MONTGOMERY COUNTY HISTORIC PRESERVATION COMMISSION
STAFF REPORT

Address:	7823 Overhill Rd., Bethesda	Meeting Date:	10/27/2021
Resource:	Contributing Resource Greenwich Forest Historic District	Report Date:	10/20/2021
Applicant:	Michael Bern & Rachel Roth Luke Olsen, Architect	Public Notice:	10/13/2021
Review:	HAWP	Tax Credit:	n/a
Permit No.:	967939 REVISION	Staff:	Dan Bruechert
Proposal:	Exterior Painting

Figure 1: 7823 Overhill Road.

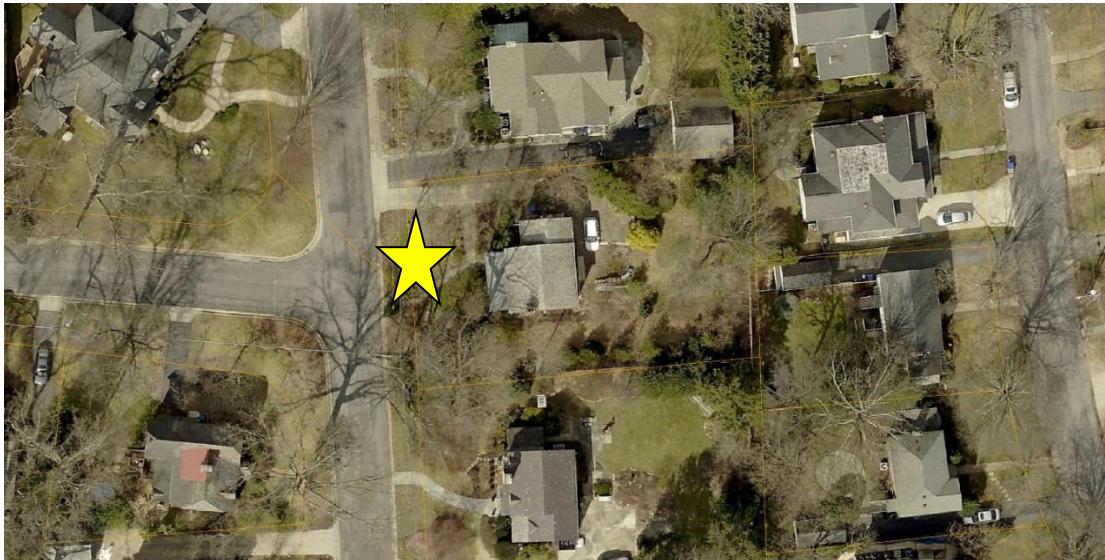
In addition to the previously approved addition, garage construction, and tree removal, the applicant now seeks approval to paint the exterior brick of the subject property. The existing exterior brick was laid in a six-course common bond.

Painting an unpainted brick surface is not a recommended historic preservation practice, primarily because it obscures the historic fabric and can rarely be completely removed without damaging the brick. That work would contravene Standard 2. However, the *Greenwich Forest Design Guidelines* provide more flexibility to property owners than even a lenient interpretation of the Standards would.

There isn't a specific guideline on painting exteriors, so Staff looks to Section A – Principals and Section B – Balancing Preservation and Flexibility, for more general guidance. Both of these sections of the *Guidelines* stress preserving the historic style and setting over specific building materials and support “reasonable modifications” and seek “a reasonable compromise between preservation and the needs of residents.”

Because there isn't a specific guideline on the work proposed, Staff considers the work under both ‘Limited Scrutiny’ and ‘Moderate Scrutiny’ as defined in the *Guidelines*. ‘Limited Scrutiny’ emphasizes the overall structure and how it interacts with the surrounding district rather than materials and architectural details. Under this level of review, the proposed work should be approved. ‘Moderate Scrutiny’ *does* include consideration of the preservation of the property, but specifically states that homeowners should be afforded ‘reasonable flexibility’ and that changes should be compatible with the structure’s existing architectural design. Based on this evaluation, Staff finds support for approving the HAWP.

Staff’s review of the district finds that there are at least five brick buildings in the district that have been painted, including 8020, 8013, and 8004 Hampden Ln., 5616 Midwood Rd., and the house next door to the subject property at 7825 Overhill Rd. The Historic Preservation Office’s records do not indicate when these houses were painted. Finally, Staff considered the significance of the brick exterior. The subject property’s simple six-course common bond does not include decorative flourishes like in the front gable at 7814 Hampden Ln. nor does it include the variety of brick color selected for 5602 York Ln. Staff recommends the HPC approve the HAWP.

Staff recommends that the Commission **approve** the HAWP application; under the Criteria for Issuance in Chapter 24A-8(d) and the *Greenwich Forest Historic District Design Guidelines*, having found that the proposal will not substantially alter the exterior features of the historic resource and is compatible in character with the surrounding district and the purposes of Chapter 24A;
